From: Cocalles, Brett W
Sent: Fri Apr 16 22:04:48 2010
To: Morel, Brian P
Subject: RE: Macondo STK geodetic
Importance: Normal
Attachments: image001.gif; image002.jpg

From: Morel, Brian P
Sent: Friday, April 16, 2010 4:04 PM
To: Cocalles, Brett W
Subject: FW: Macondo STK geodetic

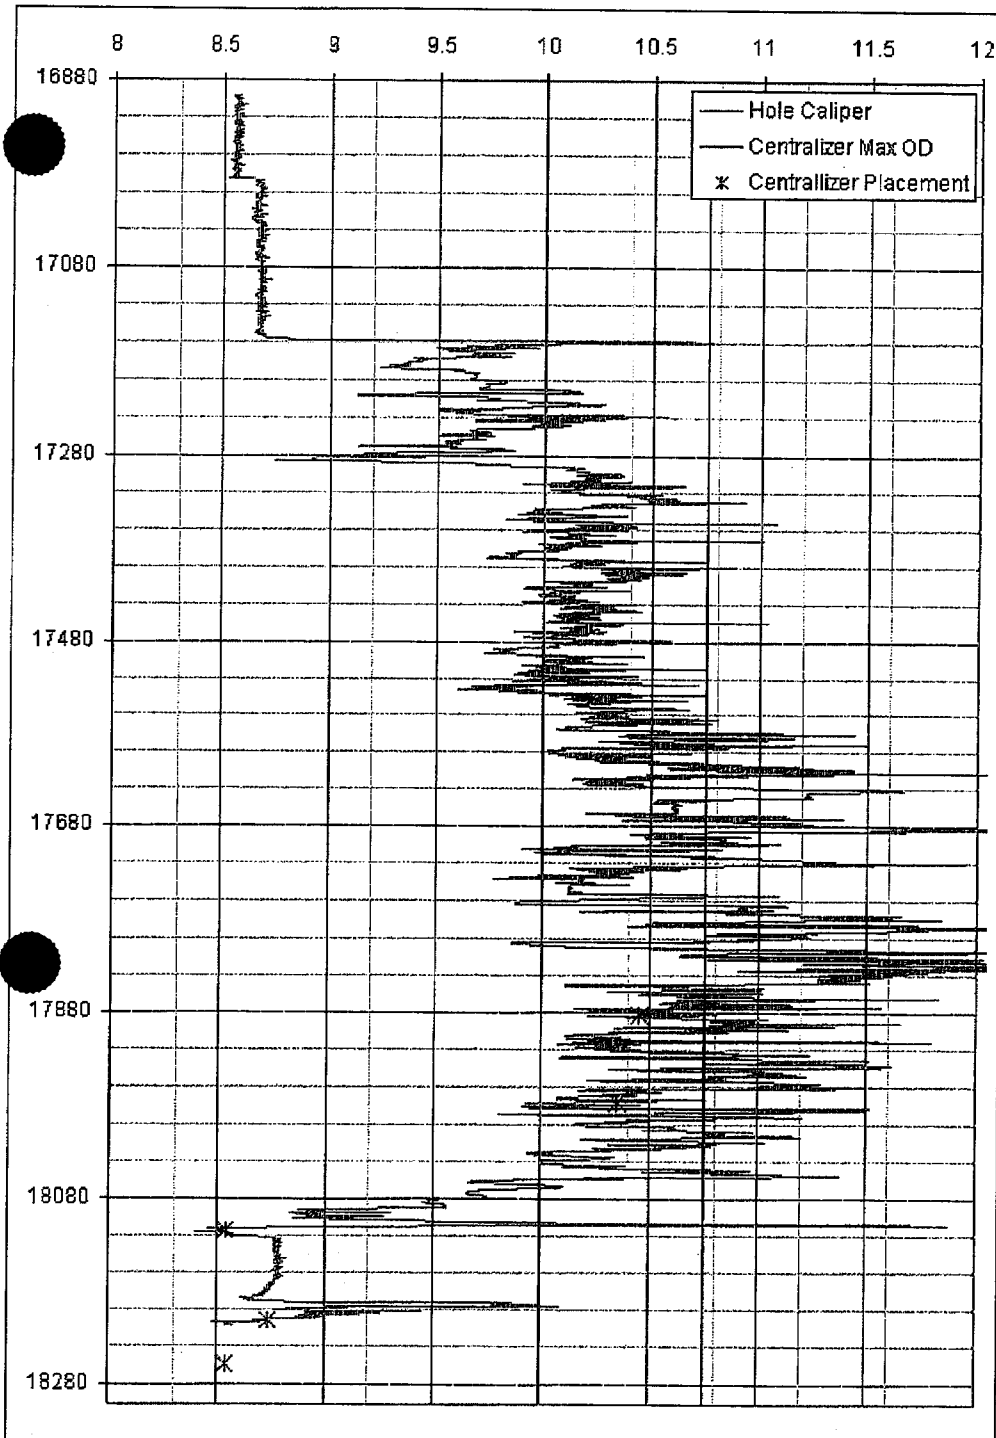
Hole is washed out if you do that, tried it before. This is all I could do to get in a none washed out interval, unless you really spread them out.

If we think the hole is relatively straight, what if you placed them every 3 joints from the shoe which almost gets you to top of cement and should maintain the pipe standoff between centralizers. With the exception if the hole is too washed out move it up or down a joint.

From: Morel, Brian P
Sent: Friday, April 16, 2010 4:21 PM
To: Cocalles, Brett W
Subject: RE: Macondo STK geodetic
See diagram below for centralizer placement. Tried to keep them in hole under 10.75" which is

max OD for bow spring subs (blue line).

This is why I don't understand Jesse's centralizer requirements. You can see from the plot we aren't moving much in terms of footage over long intervals.

That's good. If we go back to the premis that we want the best centralization across the sands and above sand for 200 ft, that is what you have and gives the completion folks the best chance to have good cement in this area. I'm good with this basis of design. Do you agree with that logic?
